SUBJECT: AMENDMENT NO. 24 TO FACILITY OPERATING LICENSE NPF-86:
FIGURE 2.1-1, REACTOR CORE SAFETY LIMIT (TAC M86059)

NORTH ATLANTIC ENERGY SERVICE CORPORATION, ET AL*

SEABROOK STATION, UNIT NO. 1

Amendment No. 24
License No. NPF-86

FIGURE 2.1-1

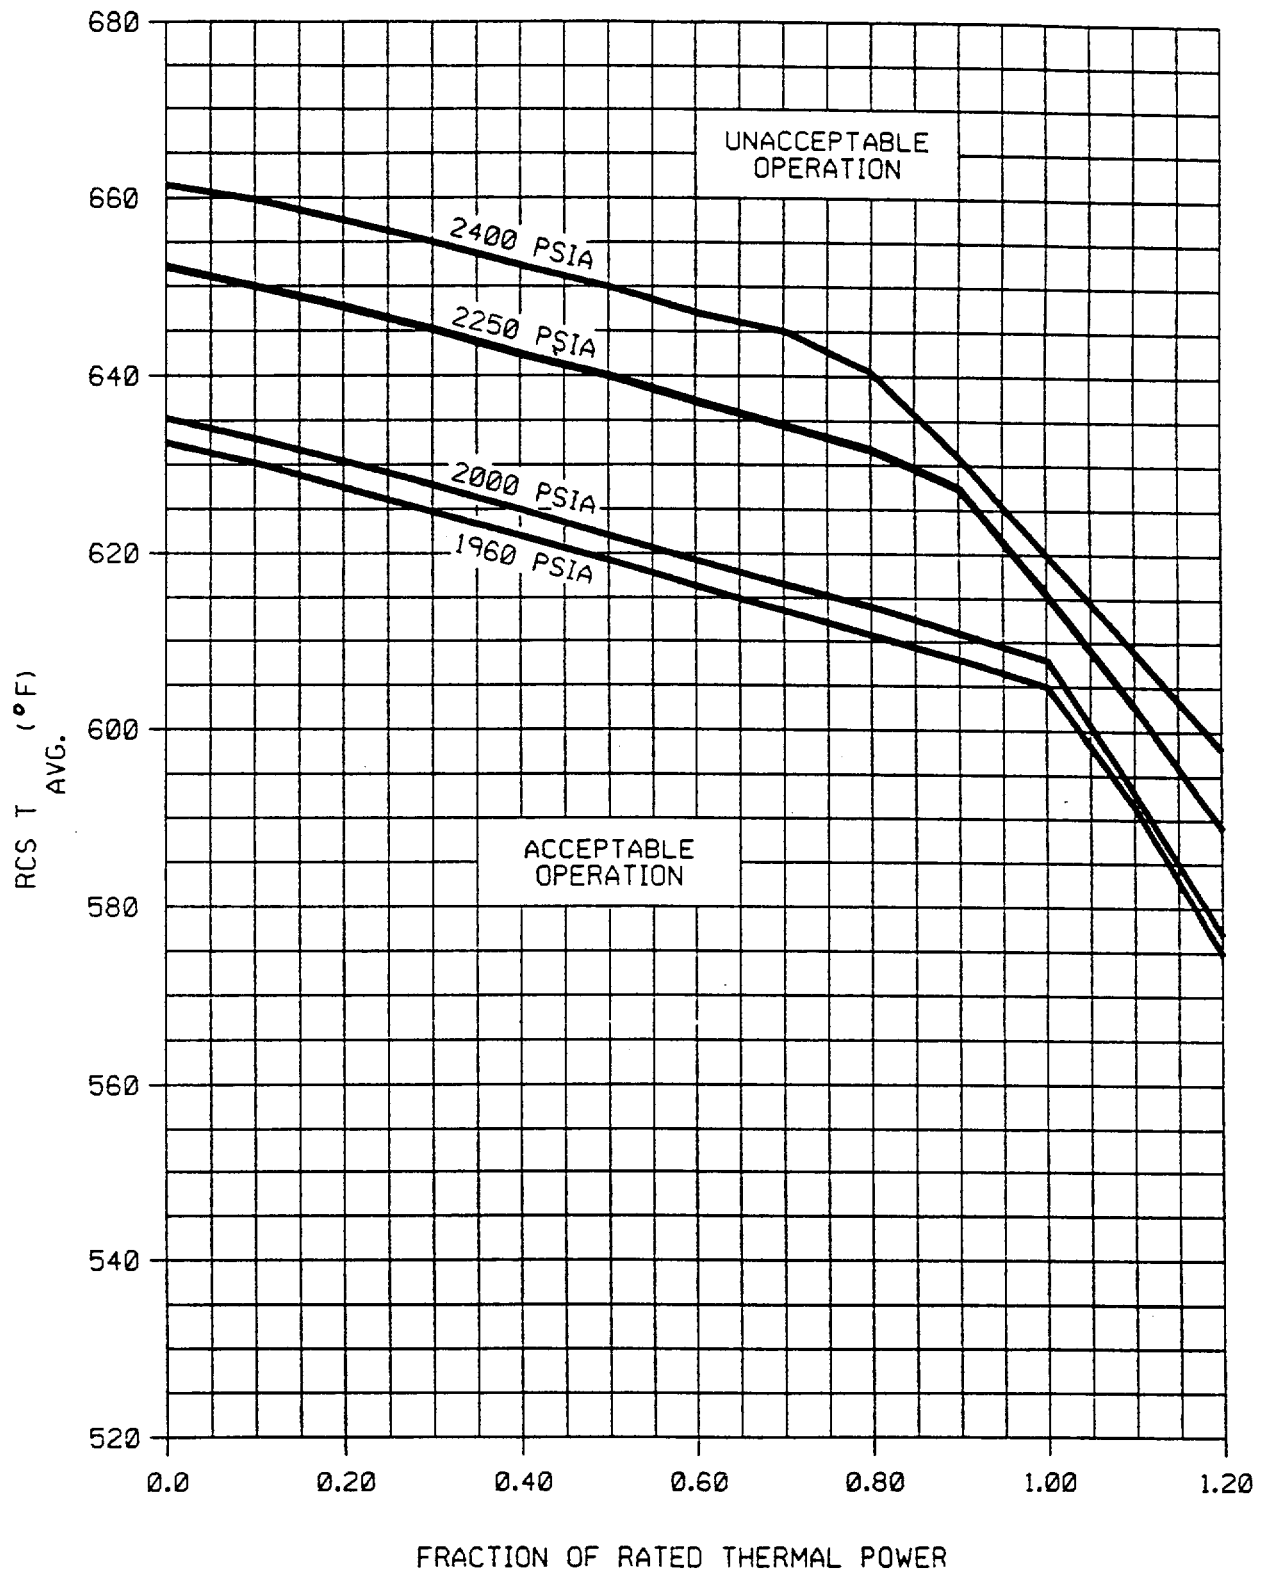
The amendment revises an Appendix A Technical Specification (TS) figure of reactor core safety limit curves. Specifically, TS Figure 2.1-1, Reactor Core Safety Limit - Four Loops in Operation, is revised to correct non-conservative curves.

By letter dated April 8, 1993, North Atlantic Energy Service Corporation (North Atlantic) submitted an amendment request for a change to the Technical Specifications (TS). The proposed amendment would revise TS Figure 2.1-1, Reactor Core Safety Limit - Four Loops in Operation, to correct non-conservative curves. North Atlantic identified that the curves were non-conservative as a result of a review of the Technical Specification values provided to North Atlantic by Westinghouse. North Atlantic determined, through a comparison of Westinghouse design documents to the actual curves on TS Figure 2.1-1, that the curves in the region of 80% to 110% of rated thermal power (RTP) do not accurately represent the loci of points upon which the curves are based.

The curves on TS Figure 2.1-1 show the loci of points of Rated Thermal Power, Reactor Coolant System (RCS) pressure, and average RCS temperature for which the minimum Departure from Nucleate Boiling Ratio (DNBR) is no less than 1.30, or the average enthalpy at the reactor vessel exit is equal to the enthalpy of saturated liquid. Operating the reactor plant within the safety limit ensures that the integrity of the fuel is not challenged.

The revision to the curves will accurately reflect the loci of points upon which the curves are based. The new curves will ensure that if the Reactor Protection System trip functions are exceeded, the evaluations made to verify if a safety limit has been exceeded will be accurate. The proposed change does not alter the design, function, or operation of the plant. The proposed change does not affect any existing accident analyses, and does not introduce the possibility of any accidents or malfunctions not already analyzed.

Since the proposed change provides more conservative values for TS Figure 2.1-1, it does not reduce the margin of safety as defined in the bases of the Technical Specifications and preserves the margin originally established. The revision ensures that the design basis and the safety limits are accurately

reflected in the Technical Specifications and will allow proper verification that a minimum DNBR of not less than 1.30 is achieved.
